AGENDA THE SECOND MEETING OF THE MUNICIPAL HERITAGE COMMITTEE

Heritage Alteration Permit - HAP-04-23 - 637 and 639 Talbot Street Pages 2-25

Heritage Alteration Permit - HAP-05-23 - 471 Talbot Street Pages 26-38

| ST.TH | Report No. HCR-04-23 | | |
|---|---|--|--|
| Subject: Heritage Alteration Permit for 637 and 639 Talbot Street – Kathy Ratchford | | | |

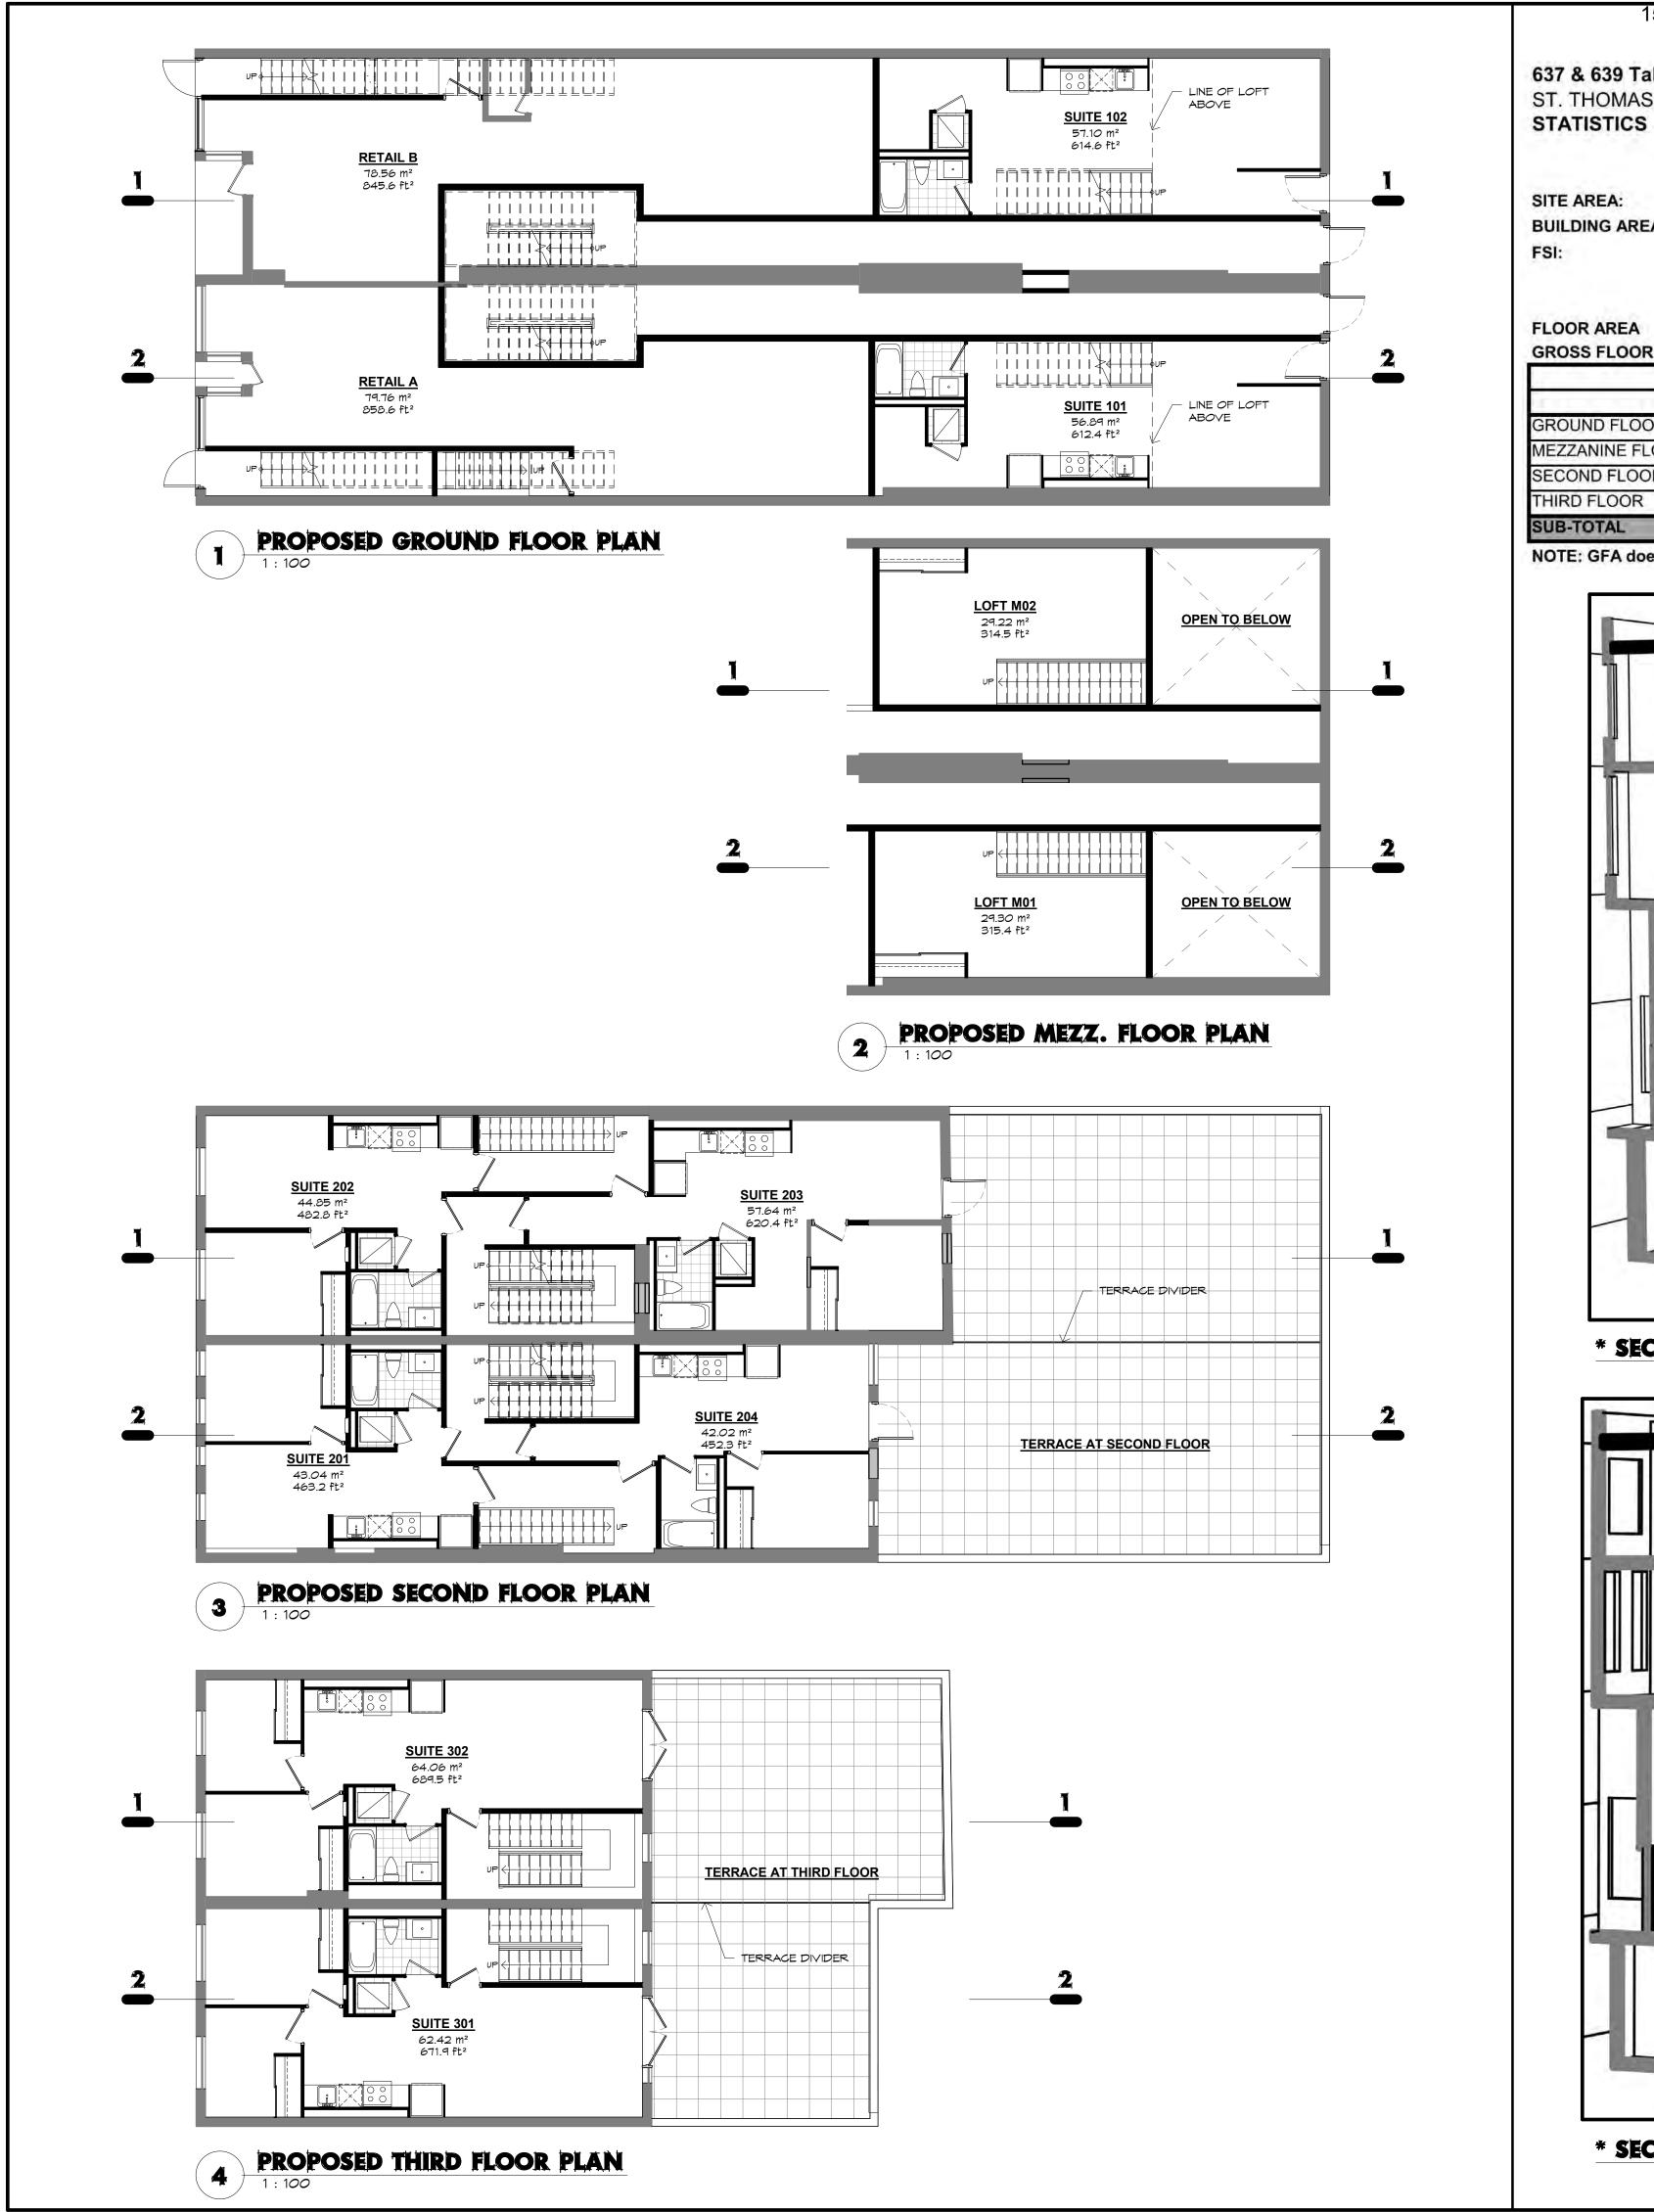
As part of the application package, it has been provided that they will be restoring the Talbot Street façade to its original condition and provided several photographs and images to show its previous state.

While photographic evidence has been provided that shows the historic façade of the building, the condition of that facade will not be known until the cladding is removed, nor whether there are attributes that should be maintained/protected. Given the direction provided in this section of the HCD Plan, the MHC will need to determine how it would like to approach the proposed front façade restoration plans by the applicant through the provision of appropriate conditions in a heritage alteration permit should it support the application.

PROPOSED ROOF PLAN
1:50

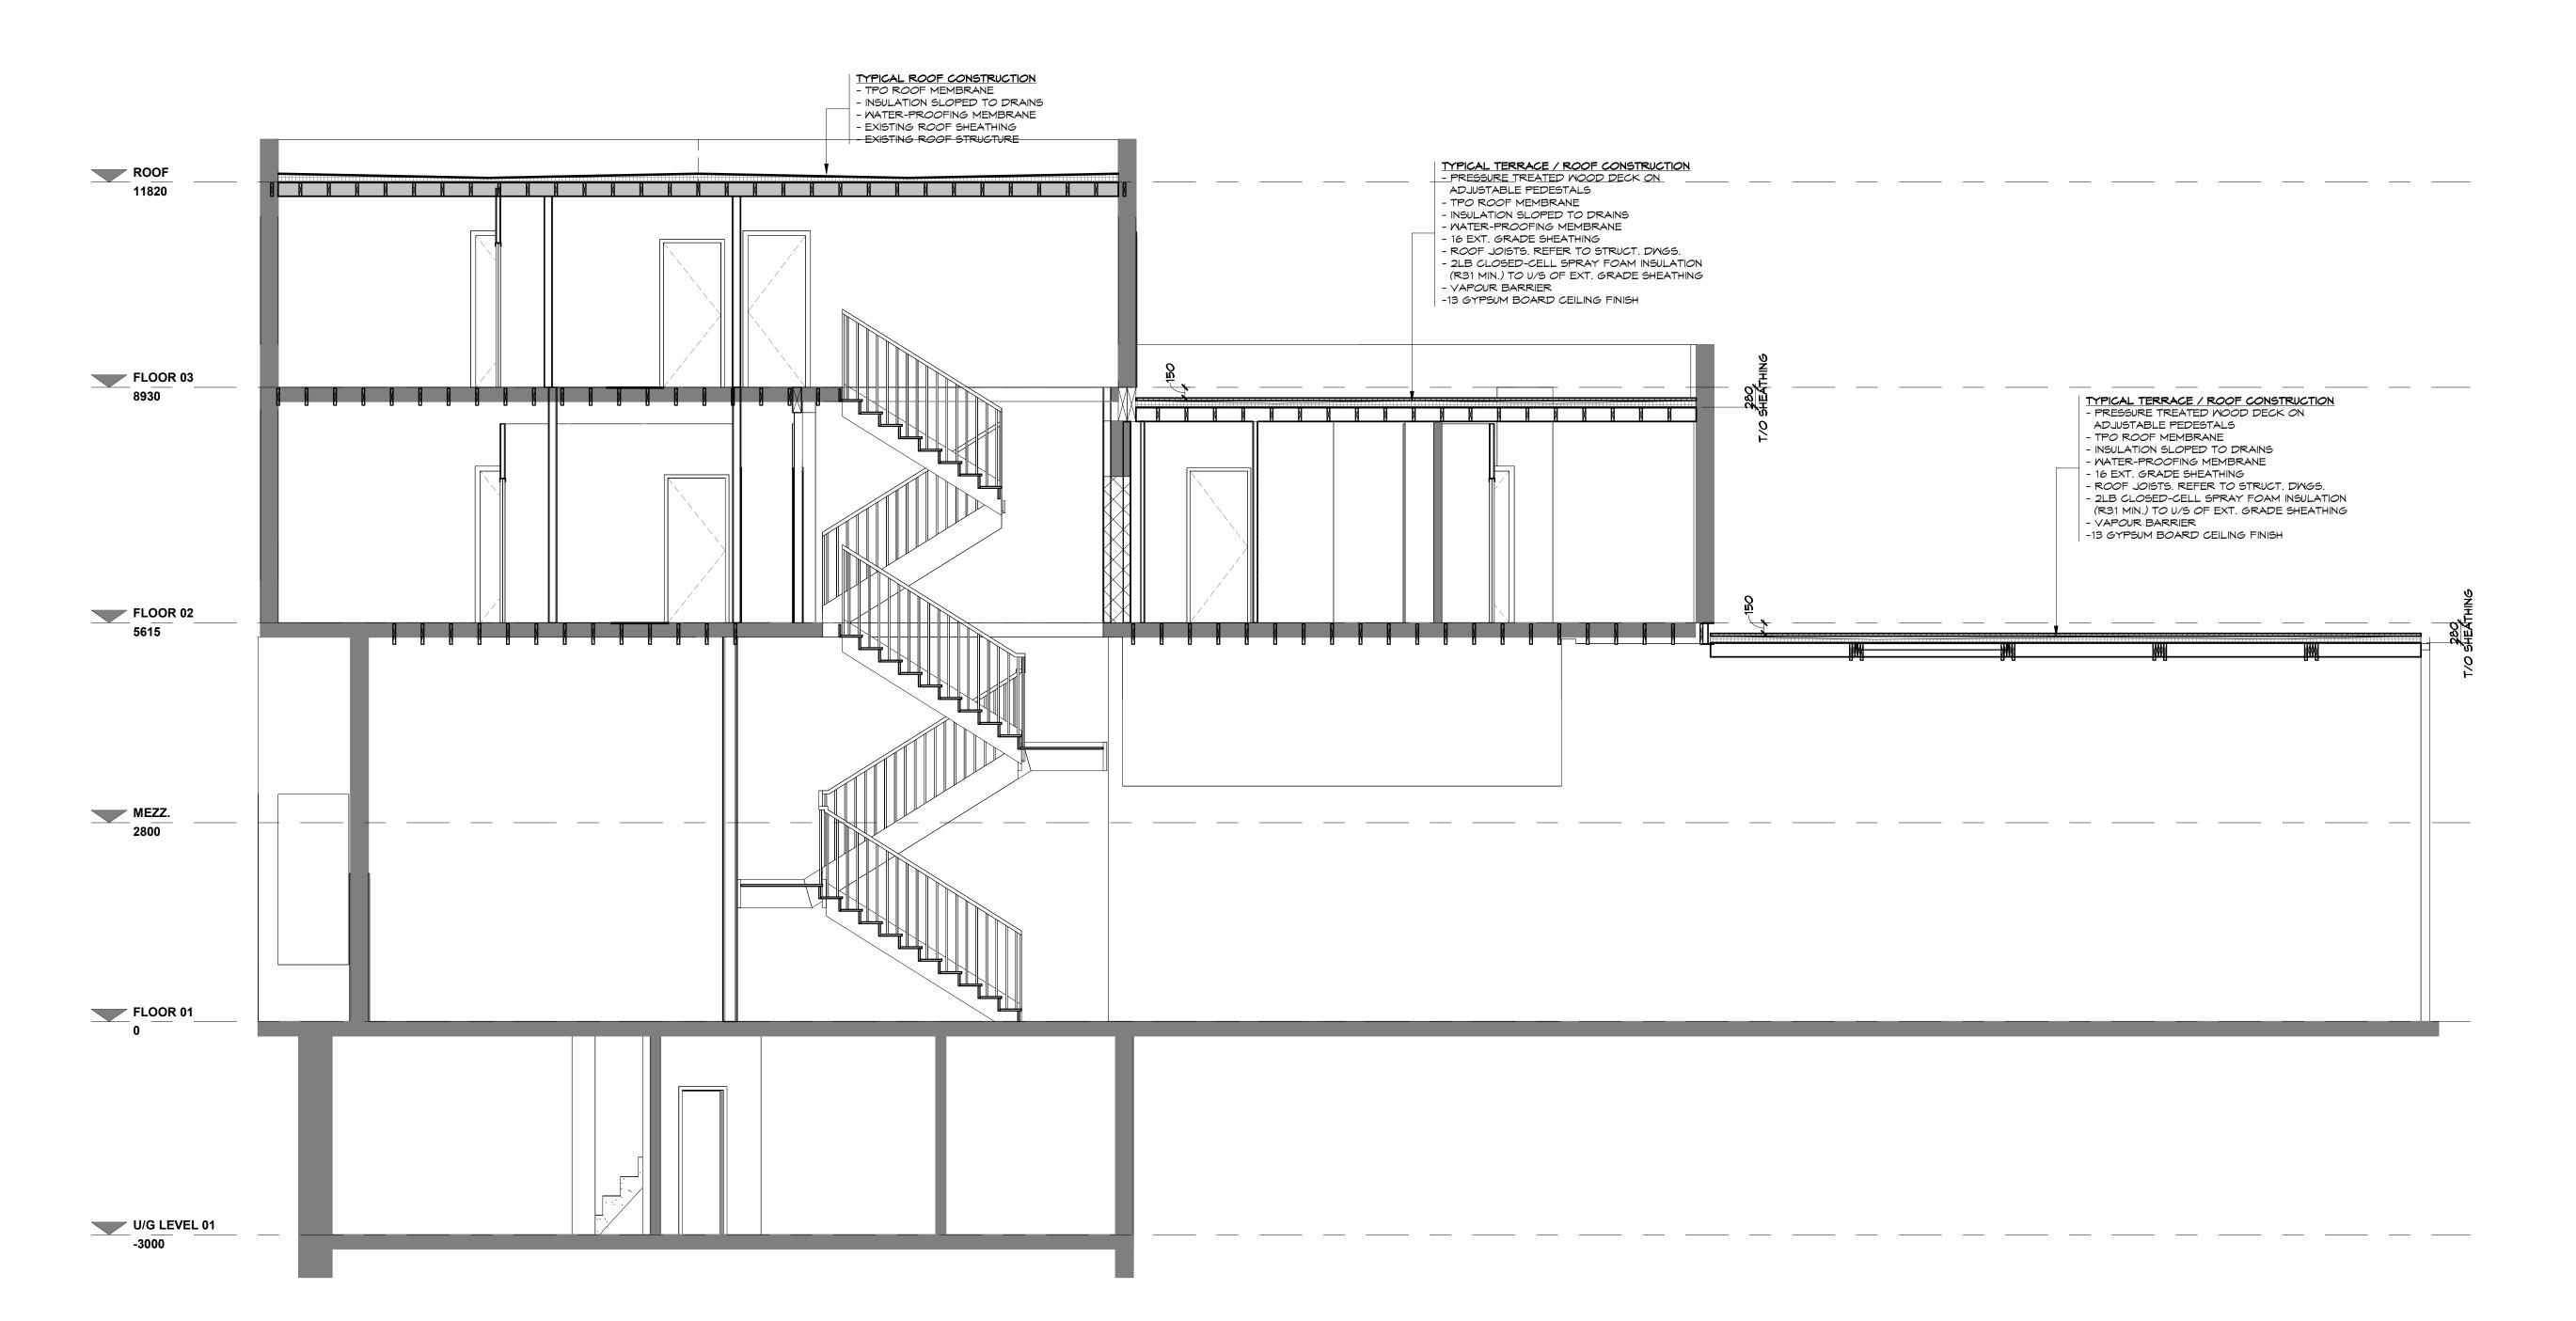
The applicant is proposing new rooftop gardens/outdoor living space for the upper units. The policies of this section speak to ensuring that roofs are properly maintained, and that mechanical equipment is set back from the roofline so that it is not visible from the street. As the alterations would be visible from a rear alleyway, and generally, not a street, the MHC will need to determine whether any of these provisions should be taken into account and included in proposed conditions should the committee be supportive of the application.

PROPOSED AUXILIARY BUILDING

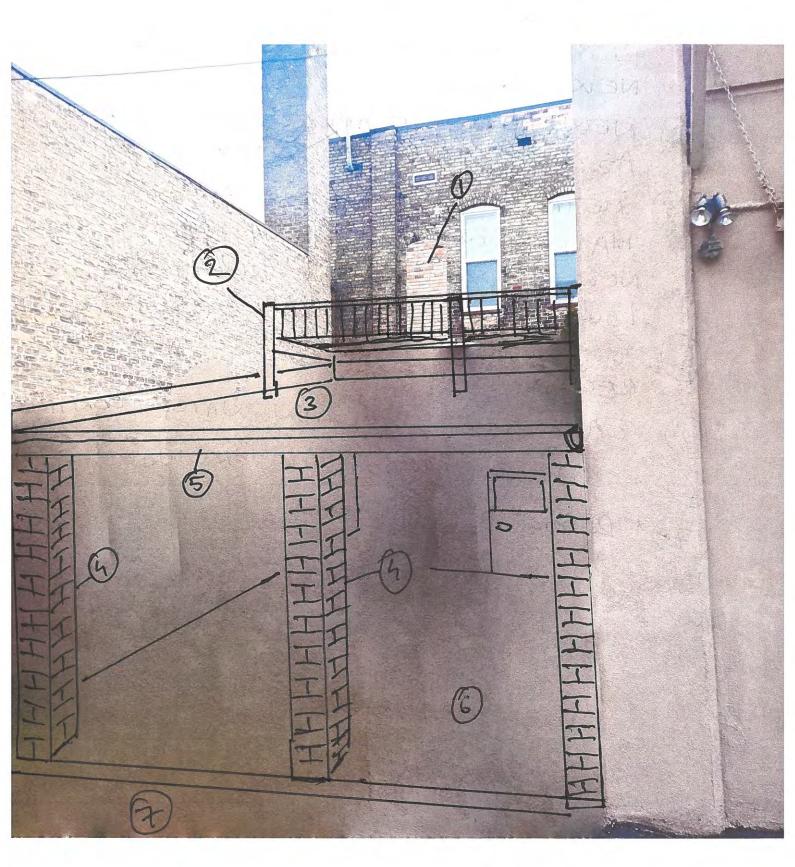
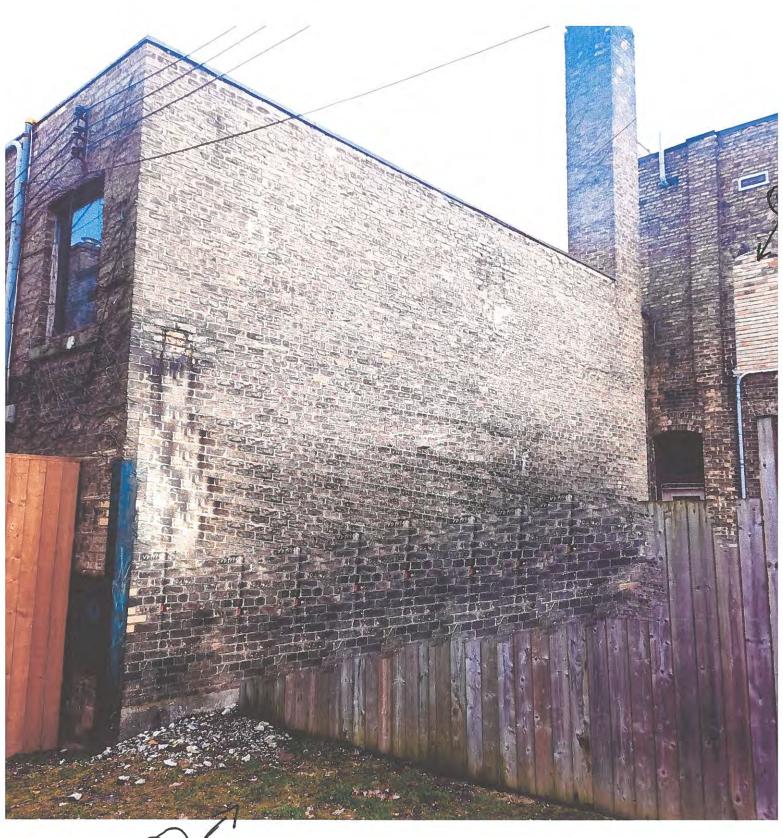
The applicant is proposing to construct an addition to the rear of the building. The structure will provide additional retail/gallery space to the commercial component of the building. A small exterior balcony/deck is proposed above the addition for use of the residential unit above. As part of the proposed balcony, the original doorway that was filled in by brick will be re-established and those bricks will be incorporated into the proposed addition. Glass or transparent garage doors are also intended to be installed at some point in the future to allow for an indoor/outdoor gallery space.

As part of this section there are policies and guidelines on "Height" that provide that, "Design additions to contributing resources to an appropriate height to contributing properties, no greater than the height of the existing building frontage on Talbot Street". As the proposed addition is of lesser height than the frontage on Talbot Street and is to the rear of the building, as such, Staff do not have concerns.

The "Massing" policies provide that additions should be subordinate to the existing building, that they are located to the rear of the building, and use shapes and massing that is compatible with the historic building and create a harmonious look with the surrounding buildings. The landowner's proposal would be subordinate to the main dwelling and is located at the back of the building, as per policy. Further, the proposed addition would maintain a similar building wall to the adjacent properties by building out to the established laneway that crosses the rear of the properties.

Staff is of the position that the proposed addition is generally in keeping with the policies and guidelines of Section 4.3.3. the HCD Plan.
